**Re: Enbridge Gas Inc. ("Enbridge Gas" or the "Company")  
Ontario Energy Board ("OEB") File No. EB-2022-0157  
Panhandle Regional Expansion Project ("Project")  
Interrogatory Responses**

ENBRIDGE GAS INC.

Figure 1: Graph of the Forecast Panhandle System Capacity, Design Day Demand (by Customer Type) and Shortfall

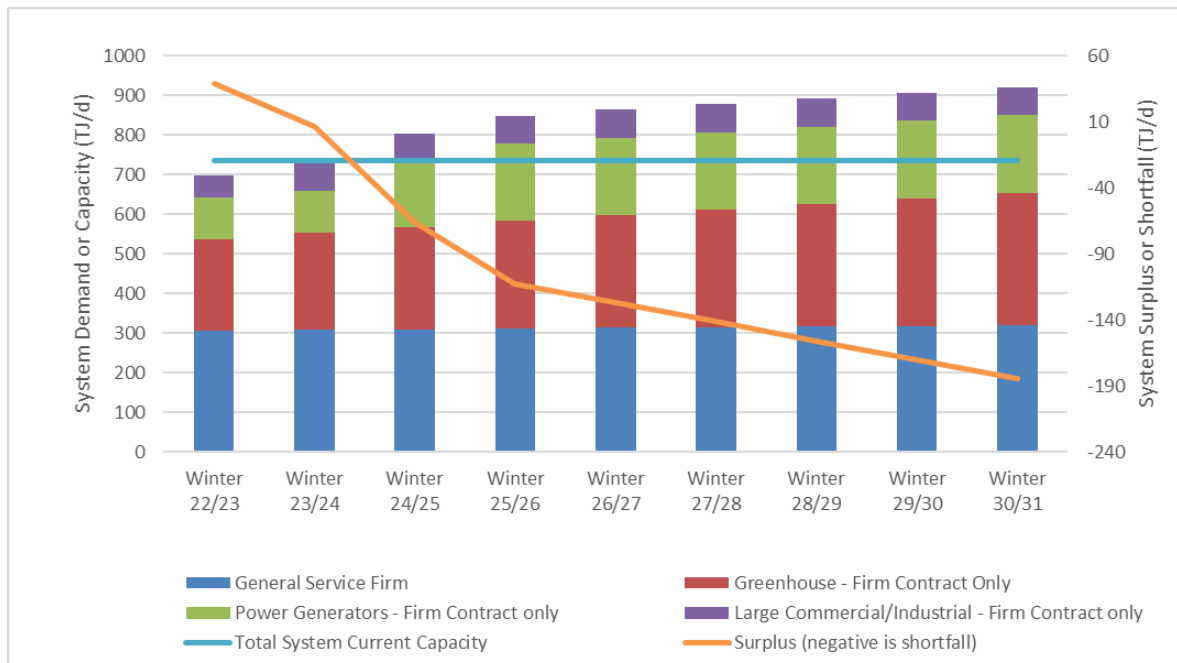
Please replicate Figure 3: Graph of the Forecast Panhandle System Capacity, Design Day Demand and Shortfall [B/2/1 Page 12] and segment the bars in the chart by the following categories:

Please see Figure 1 below.
